**BEFORE THE MILFORD TOWNSHIP  
BOARD OF SUPERVISORS**

**CONDITIONAL USE APPLICATION OF  
NATIONAL LAND DEVELOPERS, LLC**

**APPLICANT'S EXHIBITS A-22 to A-24**  
(Hearing July 25, 2023)

**RE: CONDITIONAL USE APPLICATION, MILFORD  
TOWNSHIP, PIKE COUNTY PROPERTY: 247 ROUTE 6 -  
TAX MAP PARCEL 096.00-01-16**

Figure 6. Inferred Ground-Water Flow Directions

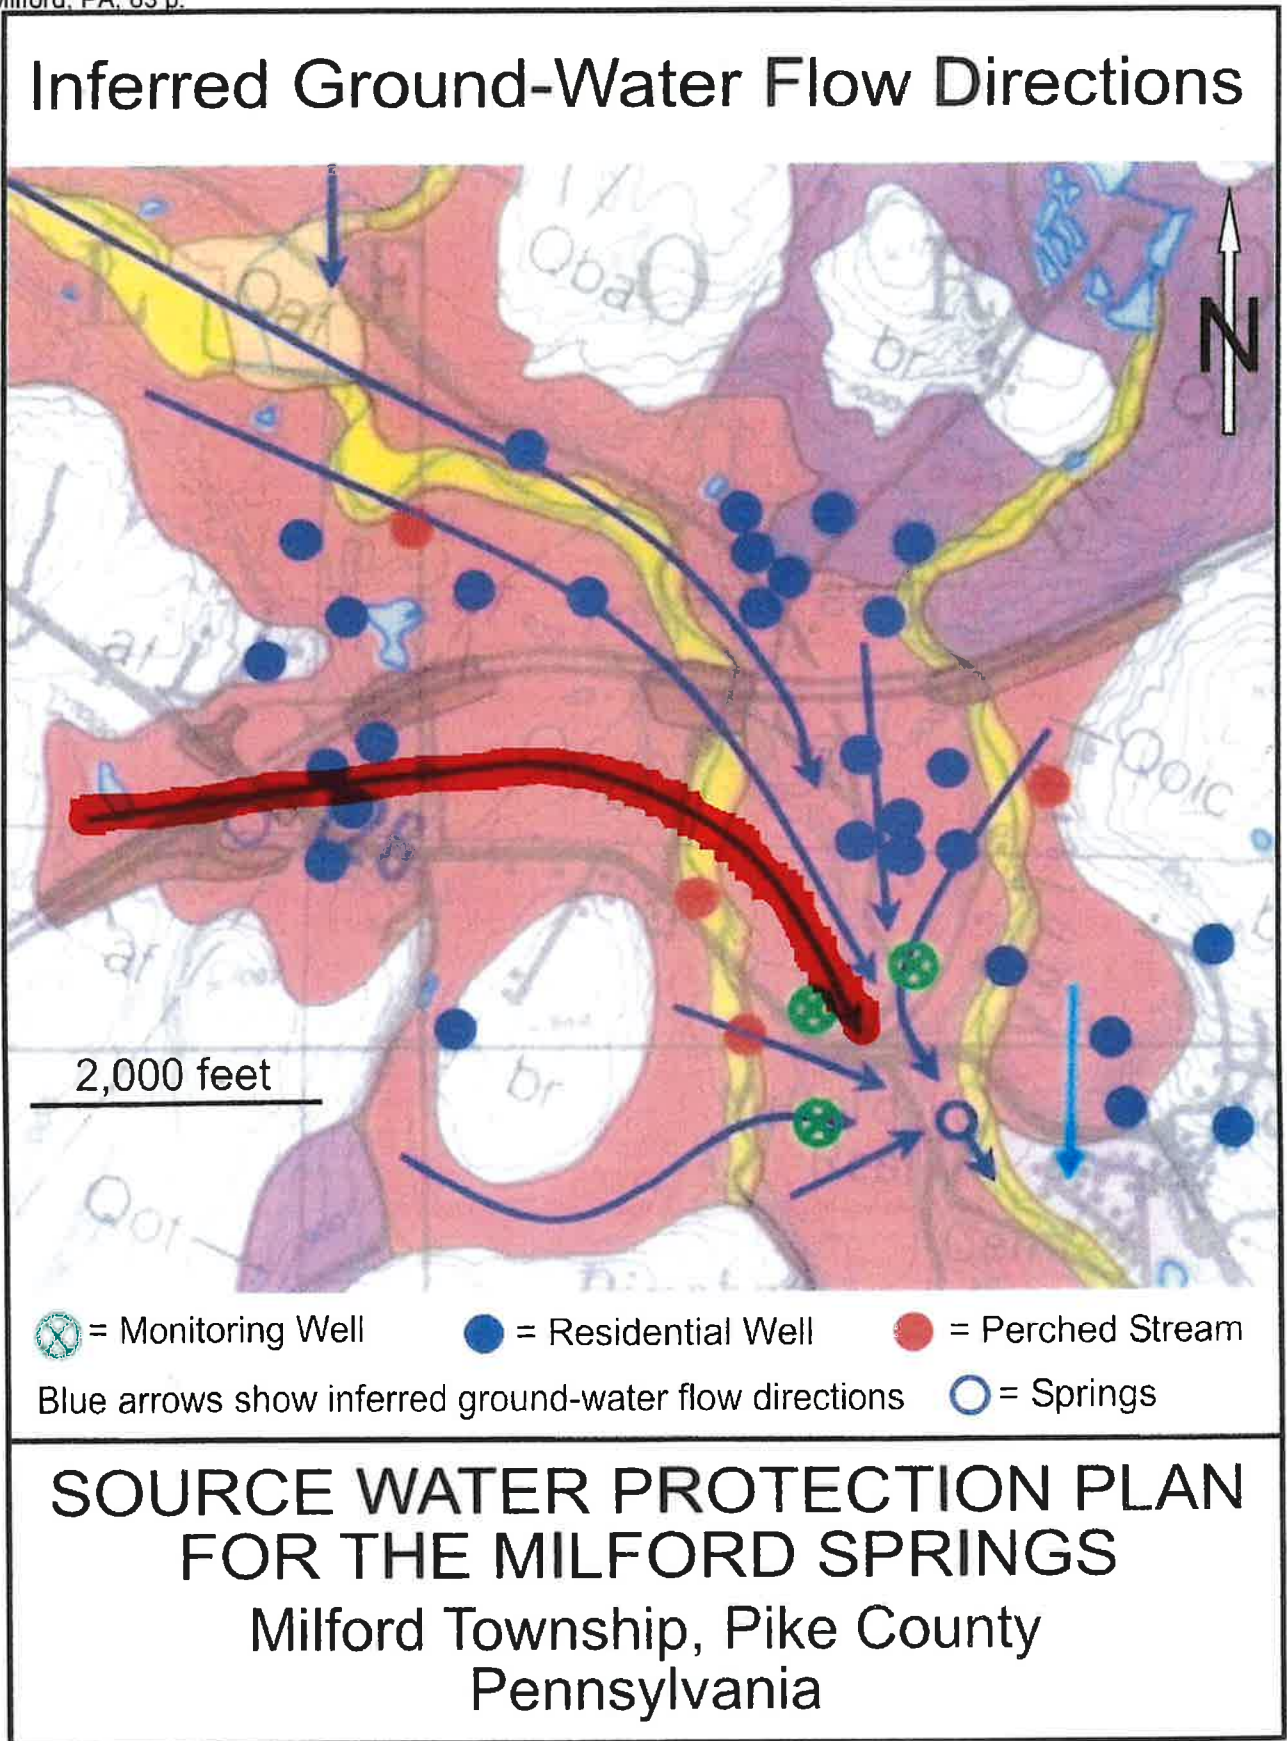
During our September 20, 2021 and June 7, 2023 visits to the Site we observed that groundwater discharges at the eastern side of the Site to an unnamed tributary to Sawkill Creek along Victory Drive. Groundwater from a western portion of the Site may discharge to the south and enter Sawkill Creek below Milford Springs. An inferred groundwater flow path shown in SWPP-Figure 6 of the Source Water Protection Plan for the Milford Springs (see attachment 1 (flow path is highlighted red)) extends eastward across the Site, passes beneath Sawkill Creek, and then extends toward Milford Springs. The flow path ignores obvious discharge points at the Site and is therefore incorrect.

Losing reaches of Sawkill Creek are also identified in SWPP-Figure 6. A losing stream has a stream stage that is higher than the adjacent aquifer's potentiometric head (i.e., hydraulic gradients must be from the stream to the adjacent aquifer). Based on the evidence presented in the Source Water Protection, the flow paths of water lost from the stream are not constrained in the Source Water Protection Plan by hydraulic head data from the surrounding alluvium and deltaic deposits. It is our opinion that the flow paths are not likely to extend to the Springs
